MFN 06-274  
Supplement 1

**Subject: Response to Portion of RAI Letter Number 20 Related to ESBWR Design Certification Application – Seismic Design – RAI Numbers 3.7-16S1, 3.7-24S1, 3.7-30S1, 3.7-33S1, 3.7-35S1, 3.7-38S1, 3.7-39S1, 3.7-50S1, 3.7-54S1 and 3.7-57S1 – Supplement 1**

**ENCLOSURE 1**

**Response to Portion of RAI Letter Number 20**

**Figure 3.7-16 (1) Original Transfer Function for RBFB in X Direction**

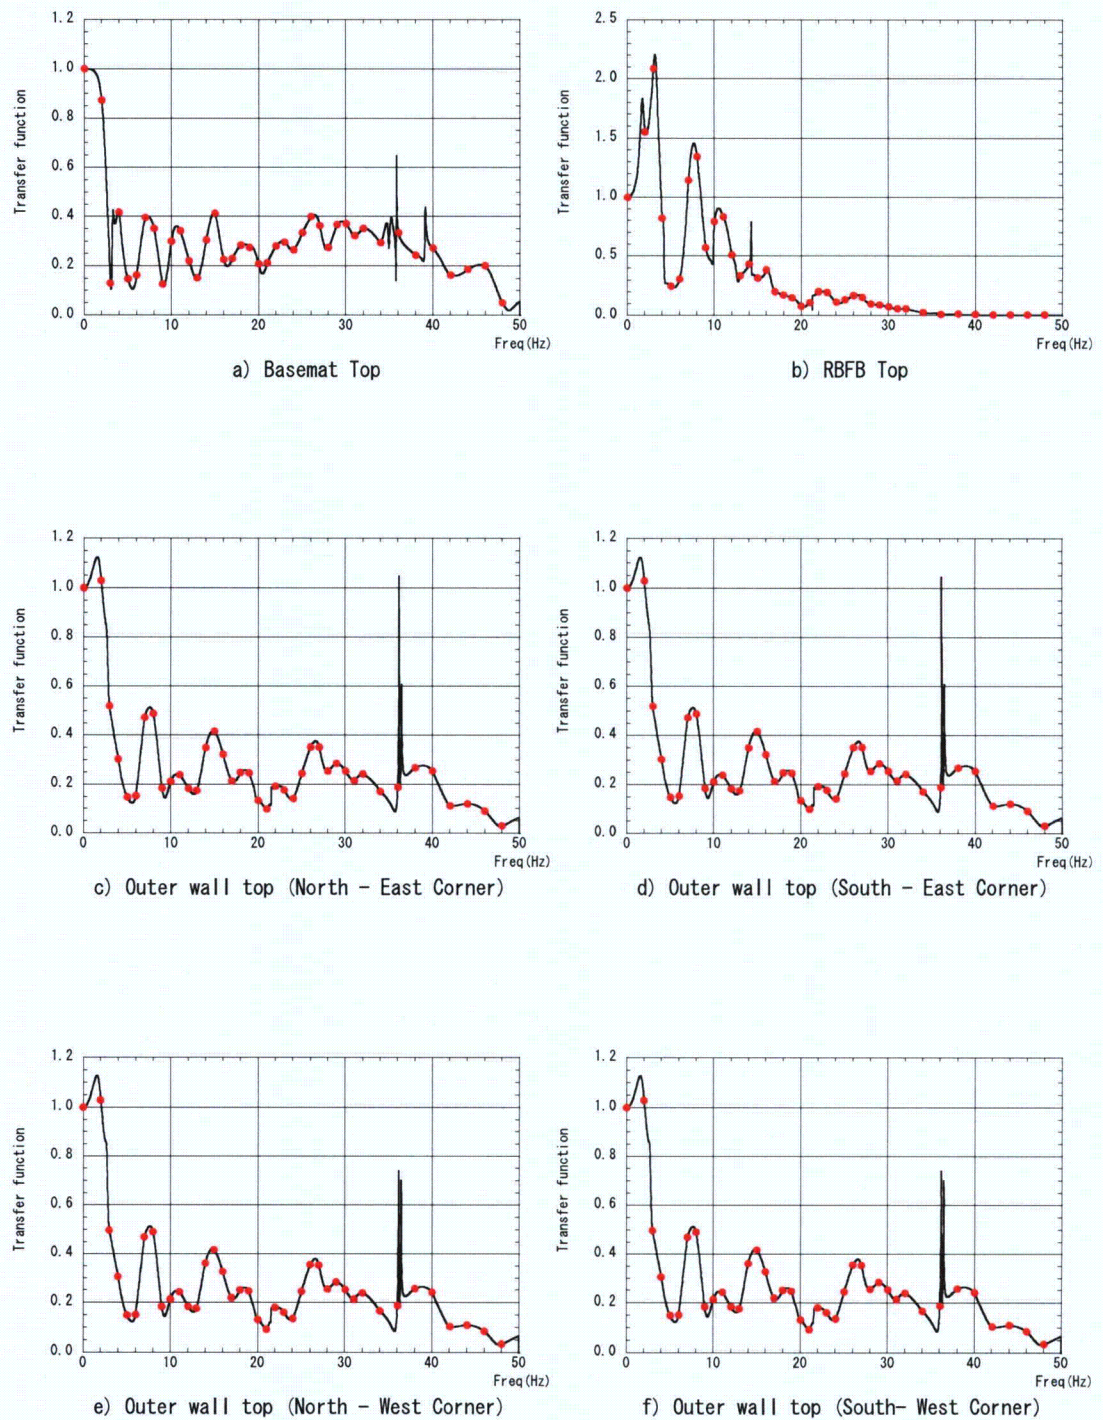
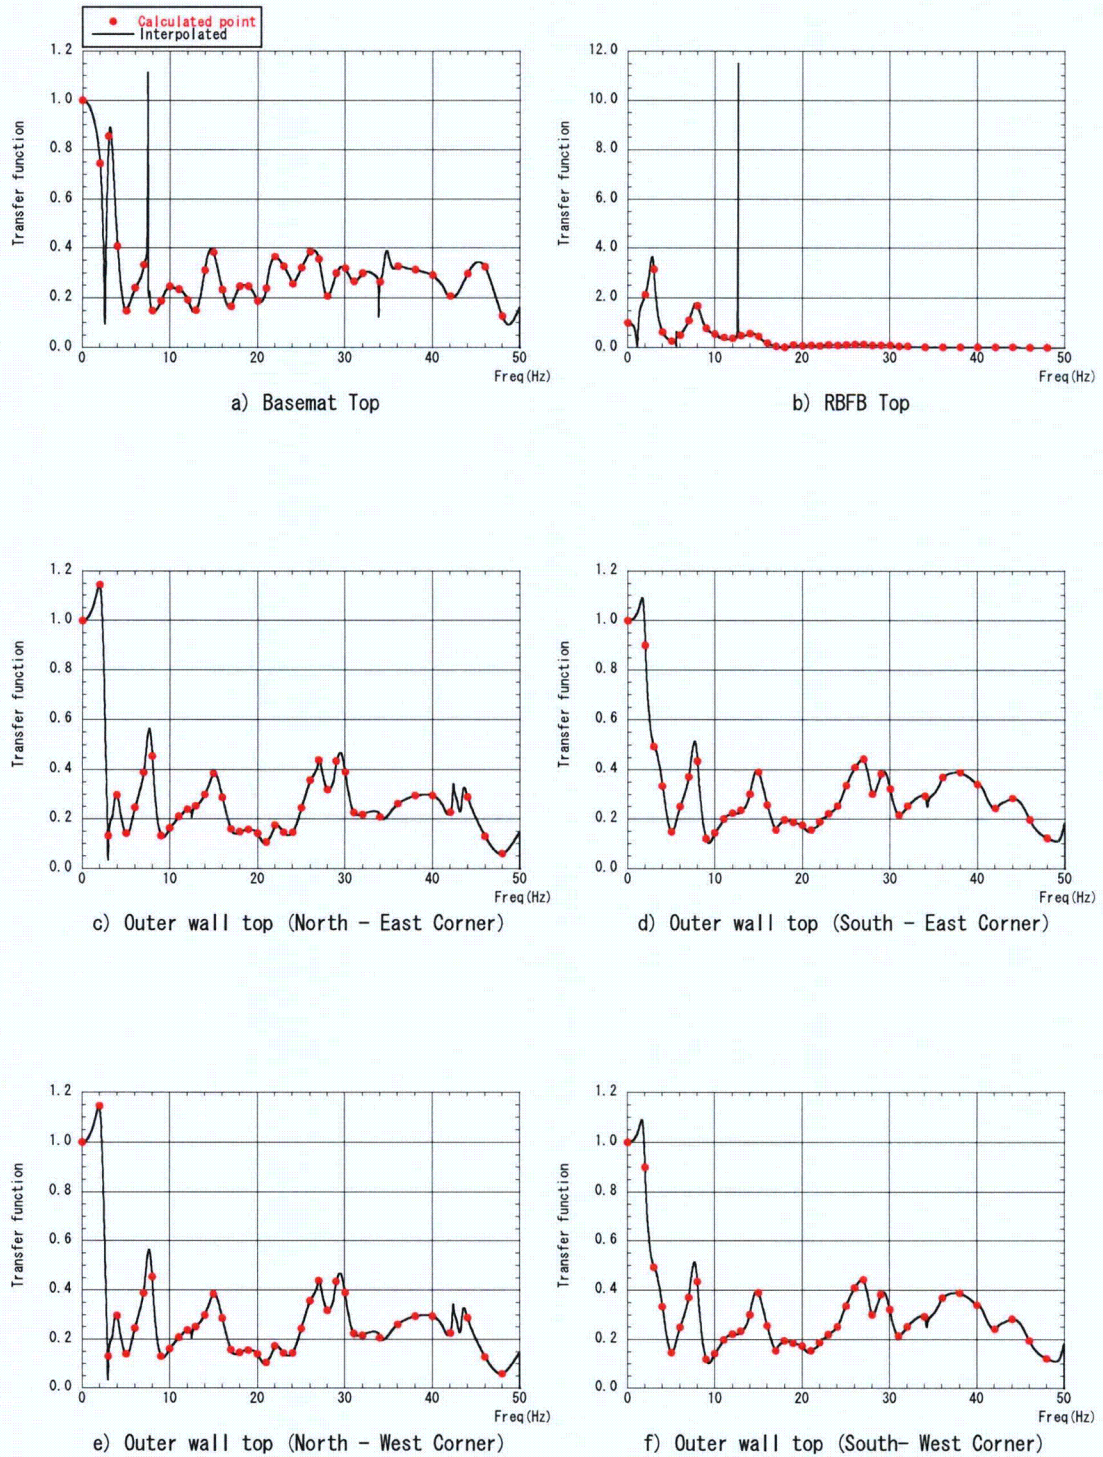
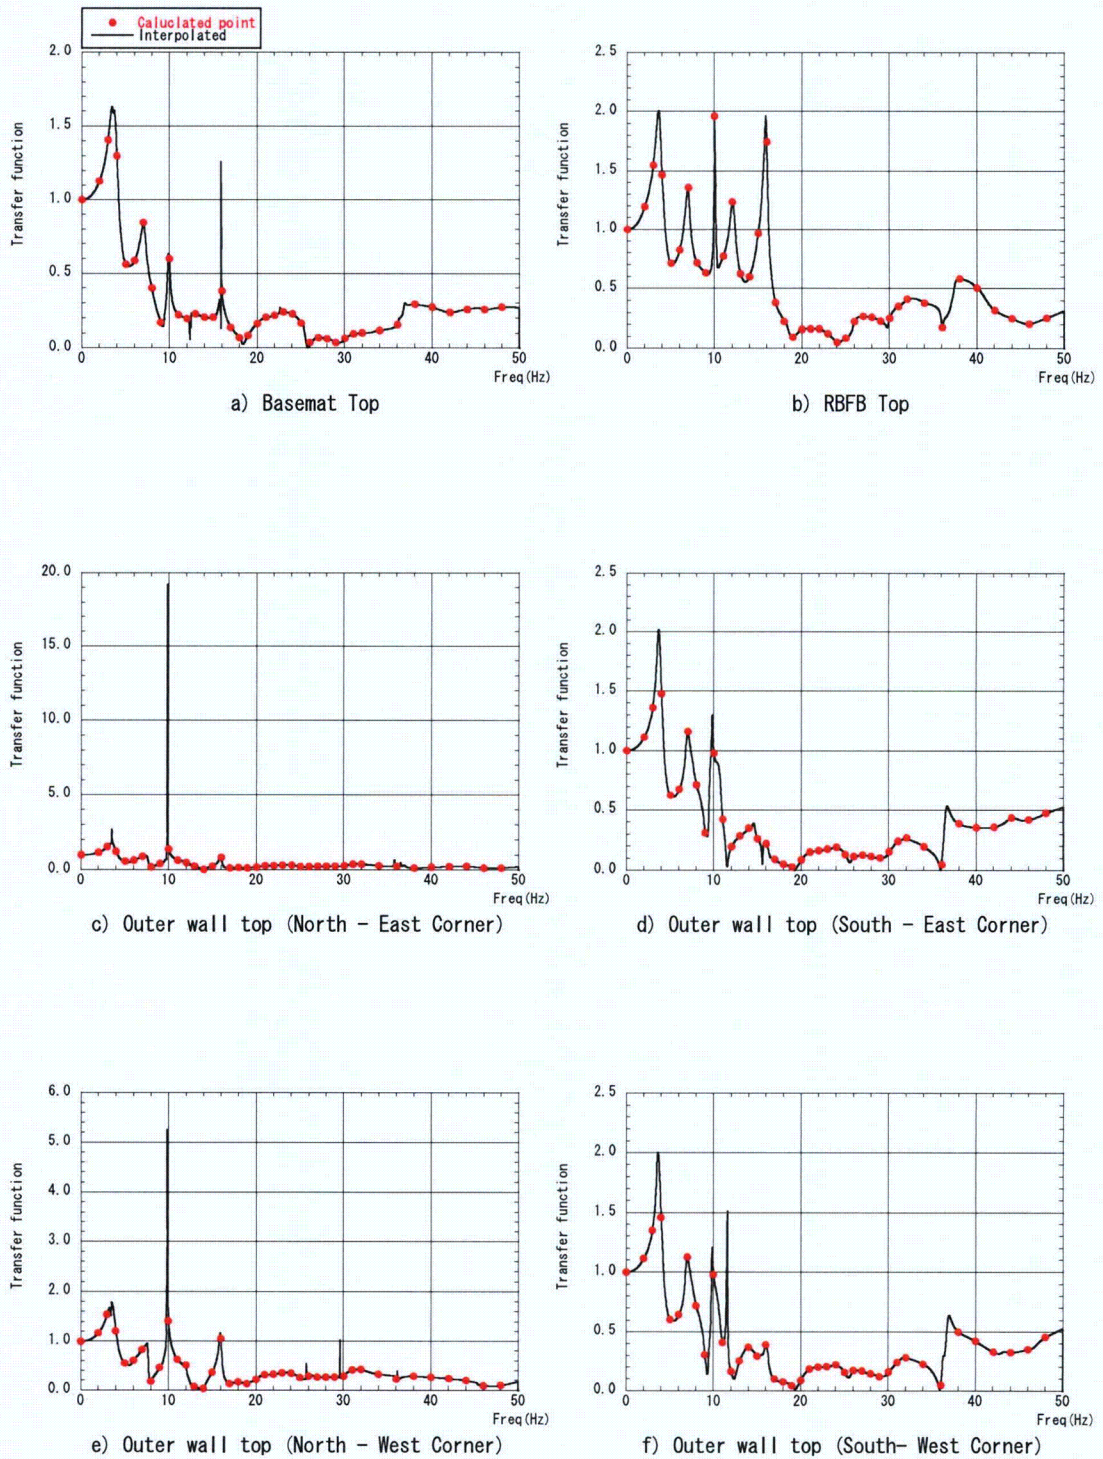
- a. *NRC staff consultants (BNL) to compare the results of their confirmatory analysis at the top of the CB and the top of basemat against the GE design spectra.*
- b. *Provide for the RB, a smooth plot of the transfer functions at the top of the building, top of the basemat and at the top of the four corners of the embedded walls.*

Figures 3.7-16 (1) through 3.7-16 (3) show the original transfer functions at the top of the RBFB building, top of basemat, and at the four corners at the top of the embedded walls, in X, Y and Z directions respectively. The soil condition is the layered site case 1 shown in the response to RAI 3.7-30 provided under MFN 06-274.

### Figure 4 ESBWR RBFB Complex Seismic Model

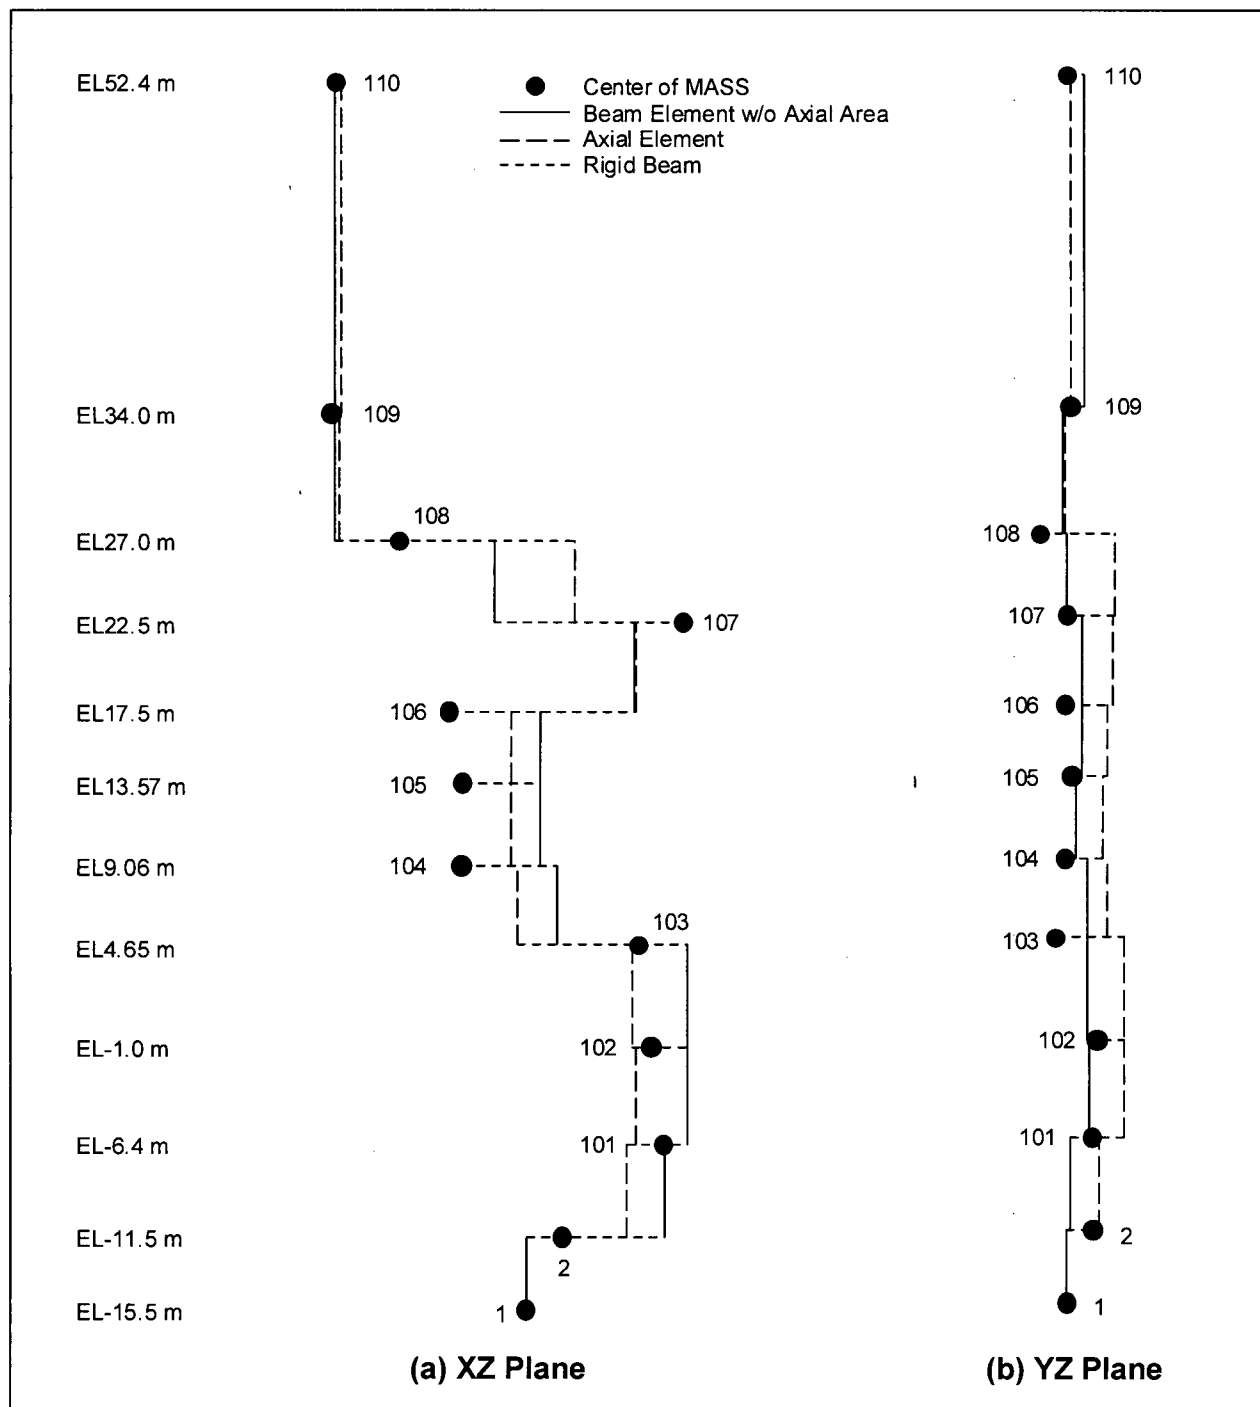
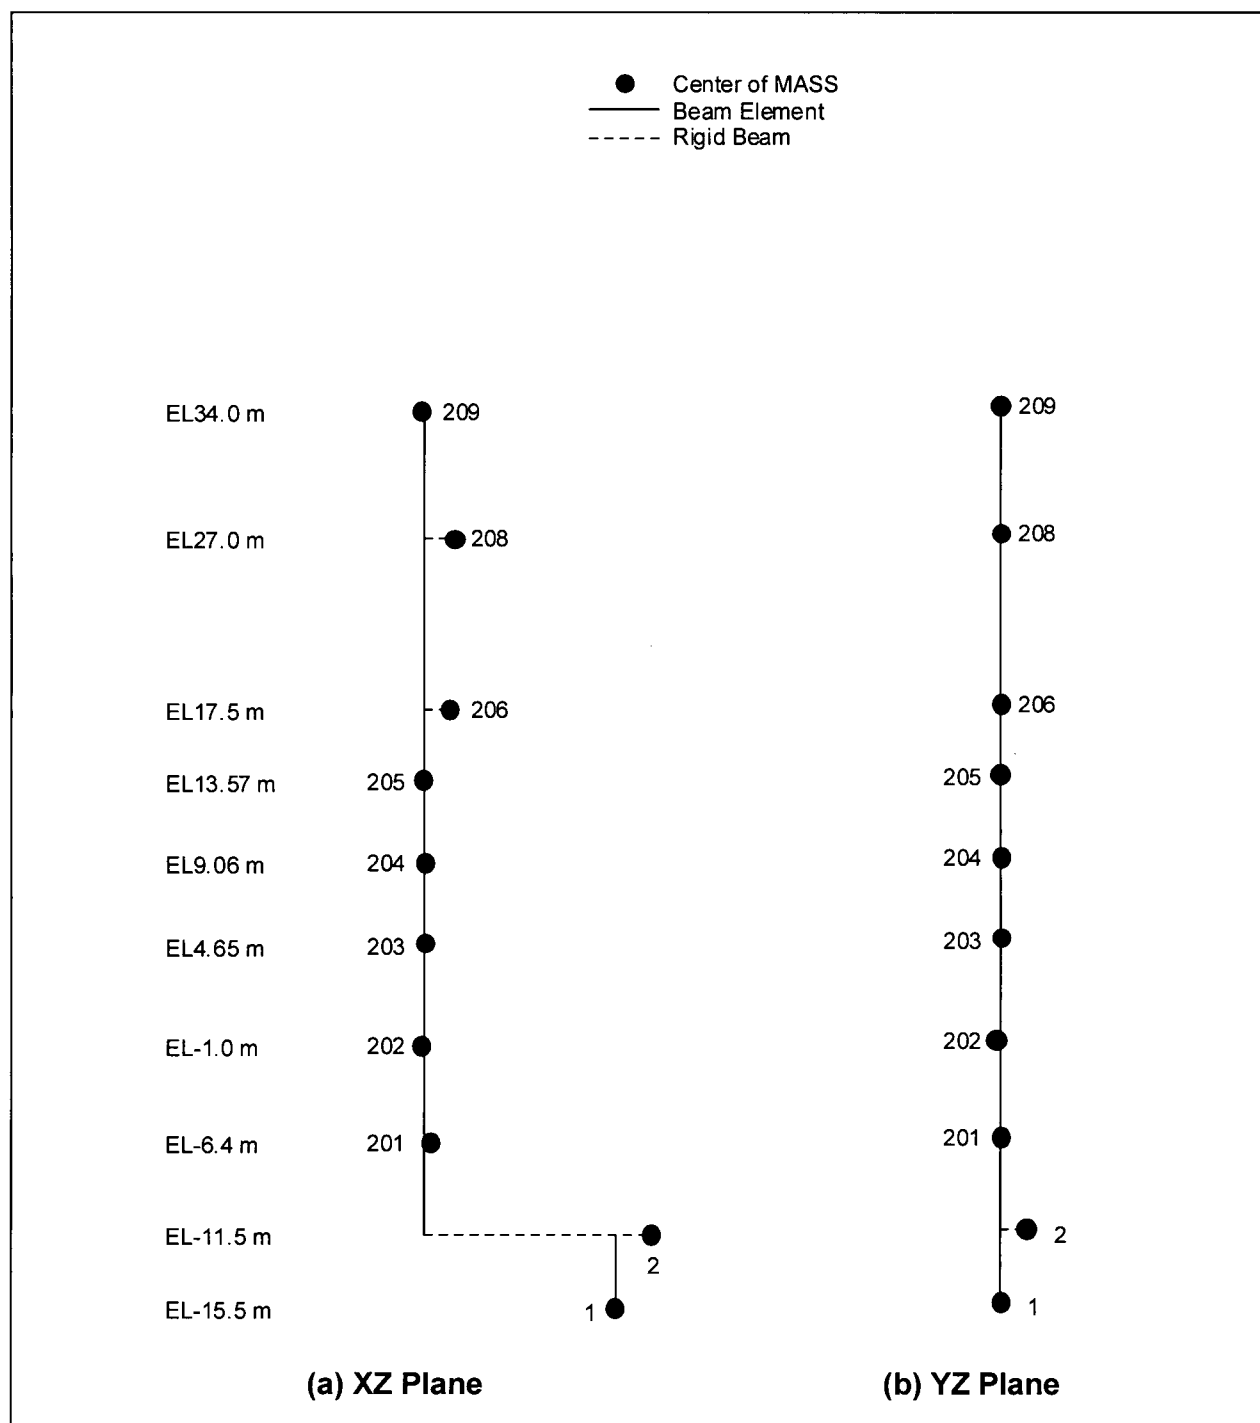
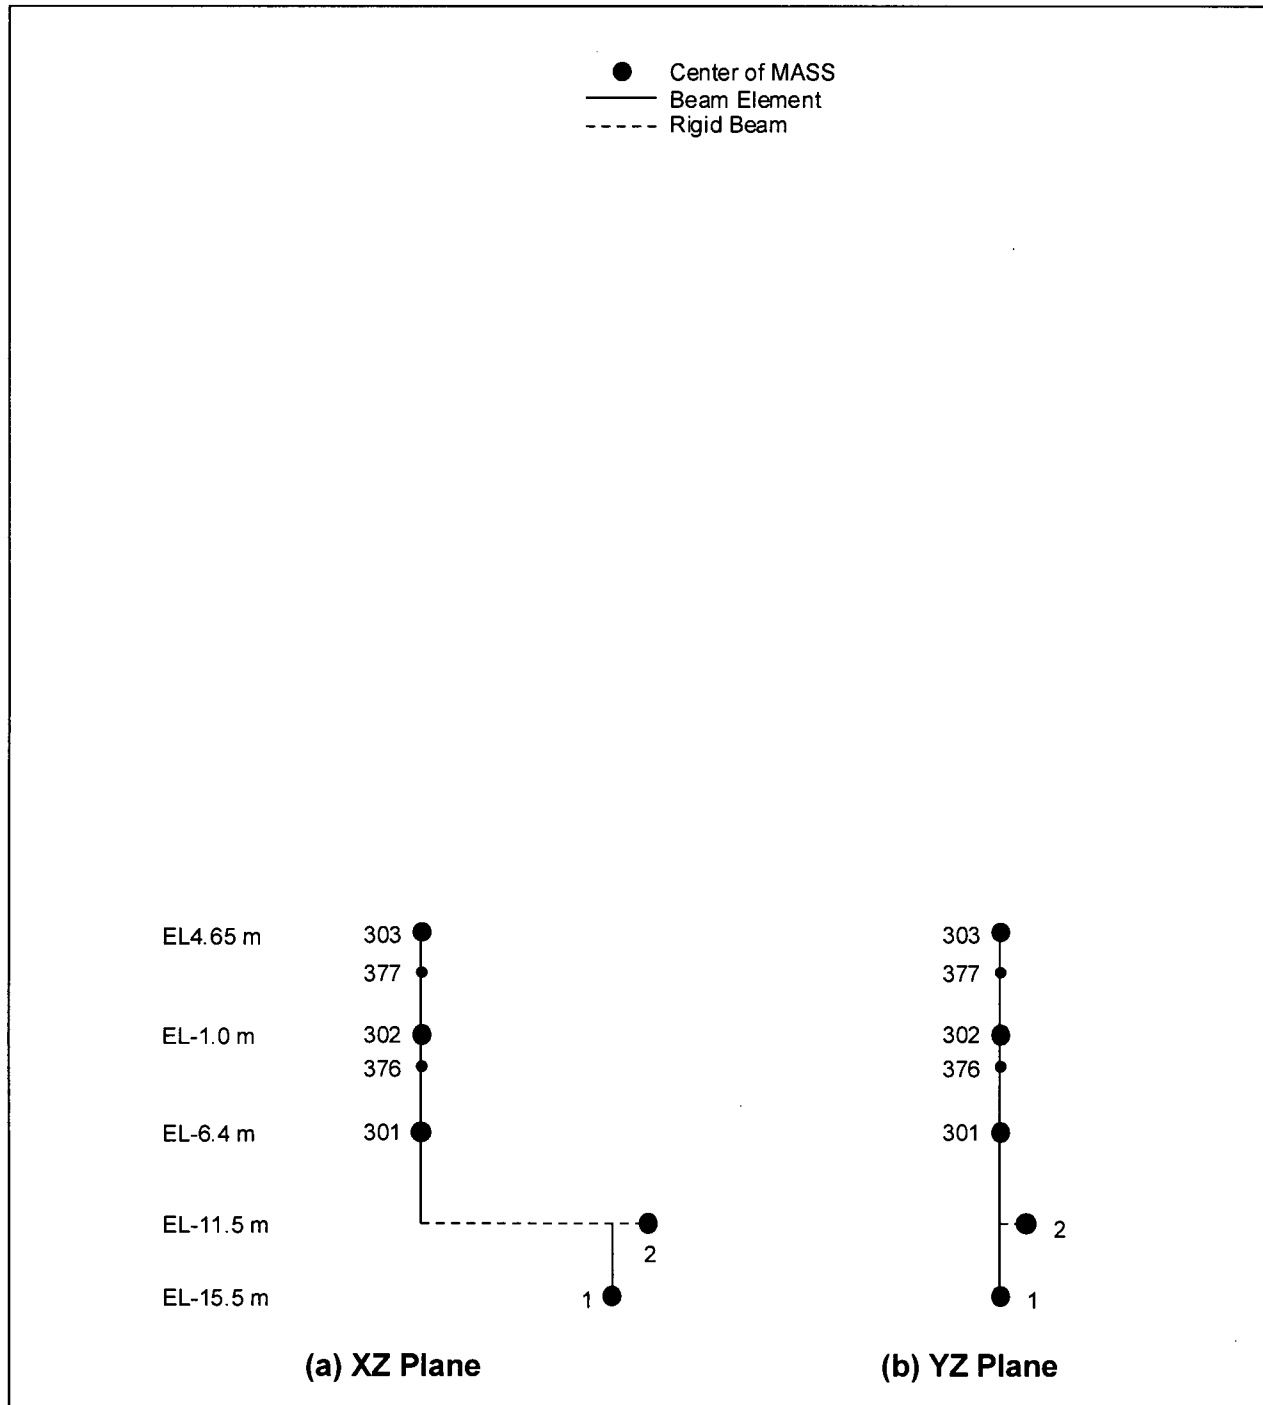
In the NRC audit, the mode shape of mode No. 3, which contains torsional mode, was discussed. The issue was why the Y direction translation of the RBFB node 107 at EL 22.5m is larger than the other adjacent floor nodes.

The RBFB seismic stick model is a 3-D model considering the building eccentricity as shown in Figures 1 through 4 in Attachment SER-ESB-054. The RBFB node 107 at EL 22.5m is located south of the other adjacent floor nodes, because of the FB roof weight. Therefore, if a torsional mode is predominant in mode No. 3, Y direction translation of this floor becomes larger than those of the other floors.
